Change of the marking on the socket of the fuseholder.

OGD/OGD-SMD					0118.2160	
creation date	created by	release date	released by	notification no.	revision	page
2013-01-22	arnetja	2013-02-18	arnetja	24330	-	1 of 2

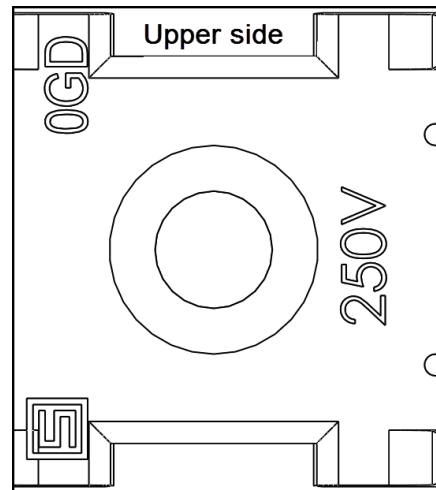
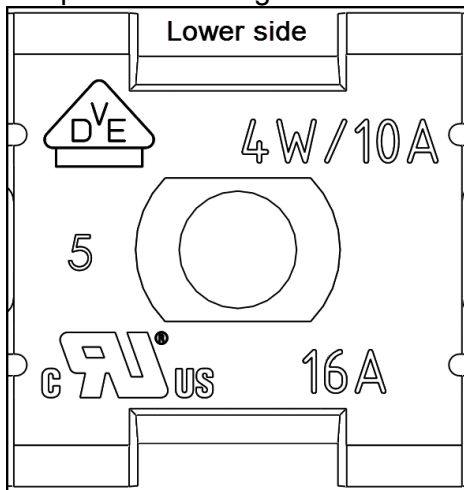
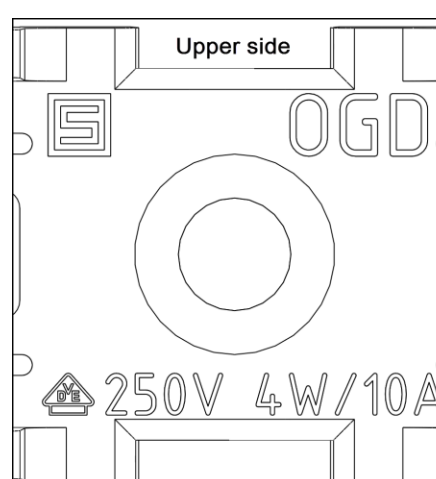
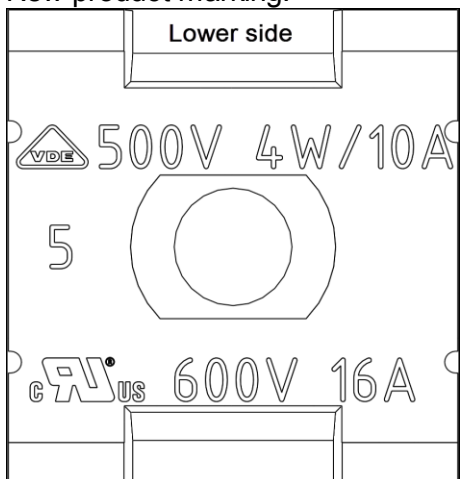
Old product marking:

New product marking:

Marking of all ratings and approvals added on the fuseholder.
